DART SERVICE INSTRUCTION TO AMEND INSTALLATION INSTRUCTIONS D350-567 REV. F OR EARLIER

AND INSTRUCTIONS FOR CONTINUED AIRWORTHINESS ICA-D350-567 REV. 3 OR EARLIER

REF CANADIAN STC: SH92-18 FAA STC: SH989NE FAA STC: SH990NE

| REV. | | DESCRIPTION | BY | DA | TE |
|------------|------|---|-------|---------|-------|
| DE APPR. | DS-W | FLOOR WINDOW CLOS | E-OUT | KIT | NTS |

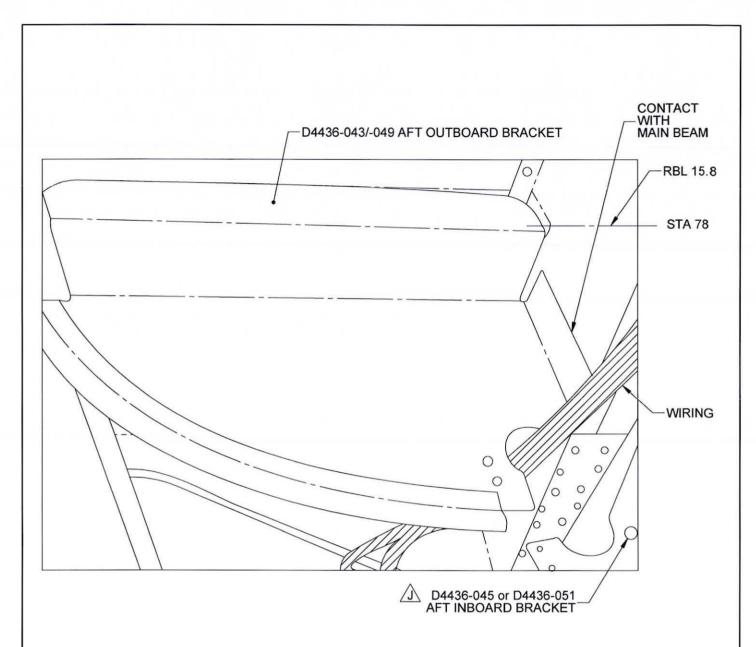
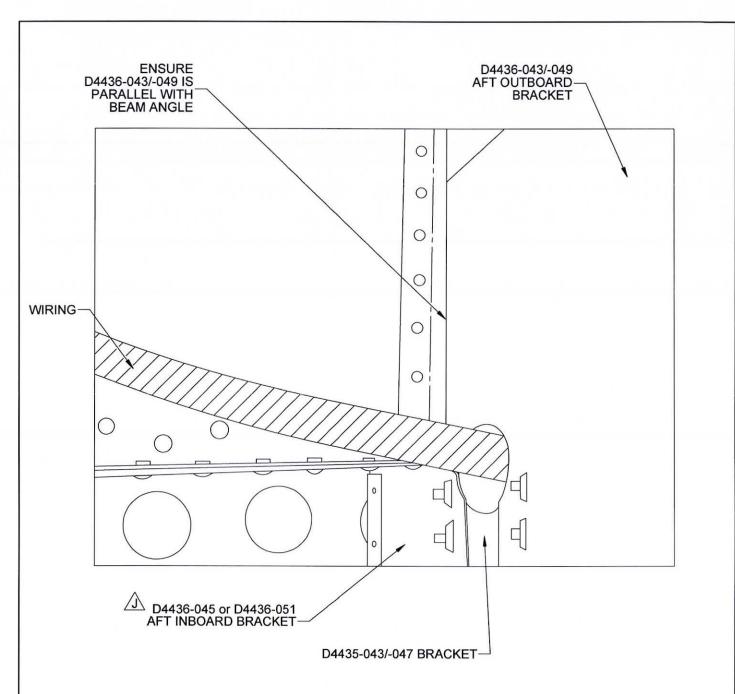
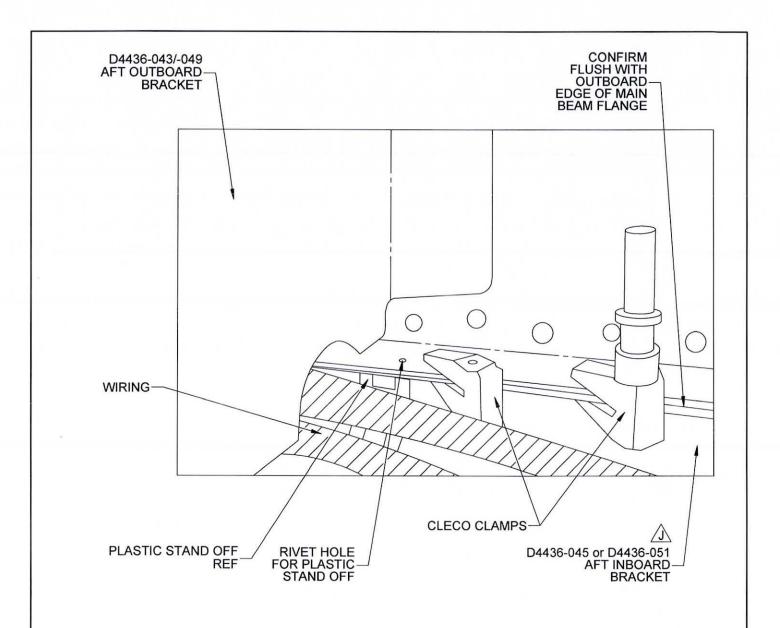
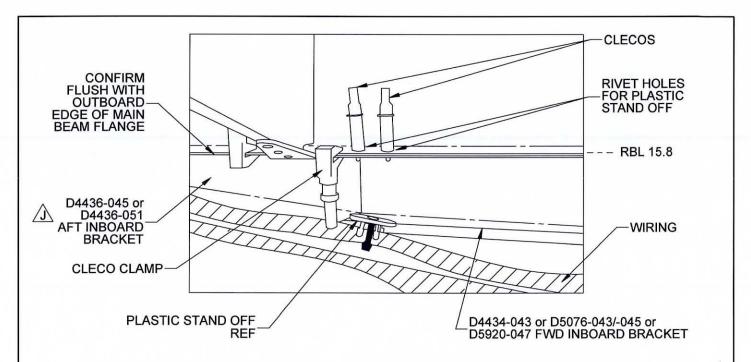
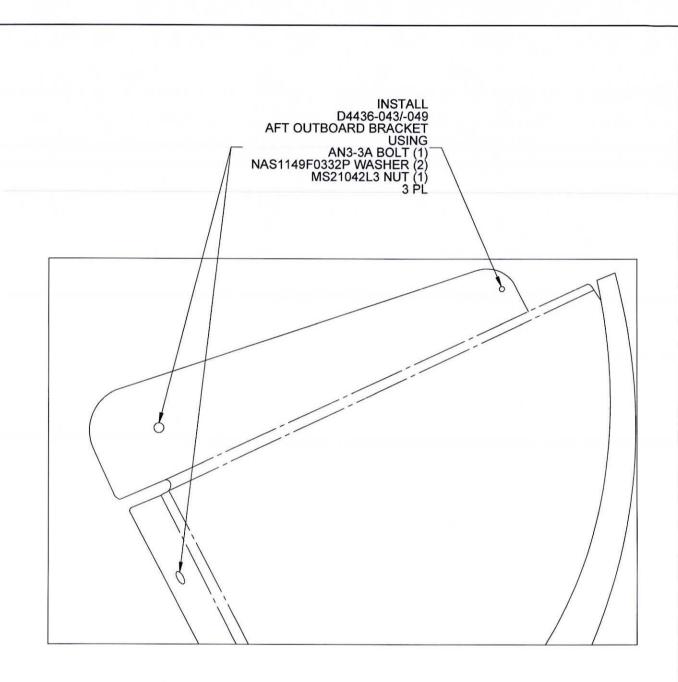
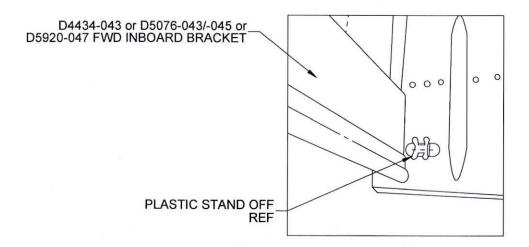
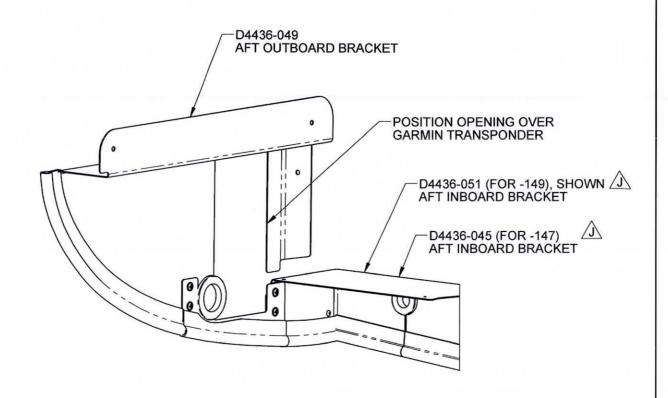
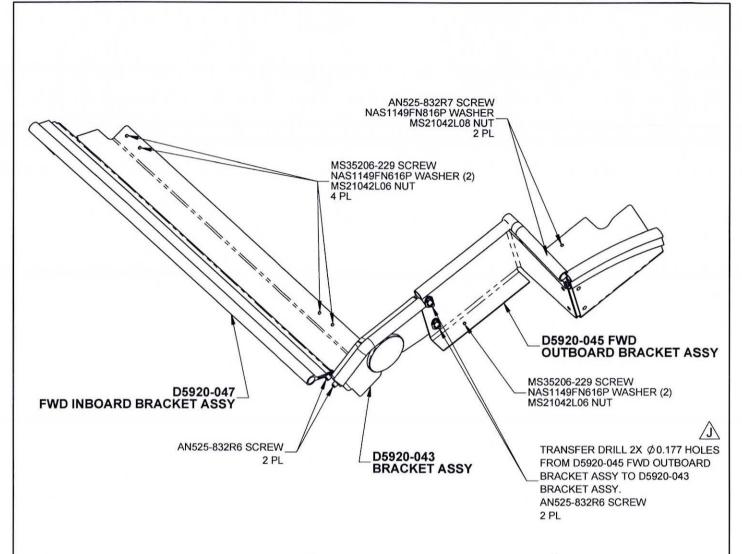
| DESIG | N RF | DART AFROSPA | CELI | ID. |
|-------|---|-------------------------|----------|----------|
| J | REPLACED D4436-045 WITH D4436-051 ON D4436-047 (-147/-149 KITS): UPDATED FIGURES 3 THRU 7, 10,15 & 16. UPDATED NOTES 4.03, 4.1,4.2,4.6,4.7,4.9 & ADDED 4.12d. REASON ECR 470 | | | 23.01.03 |
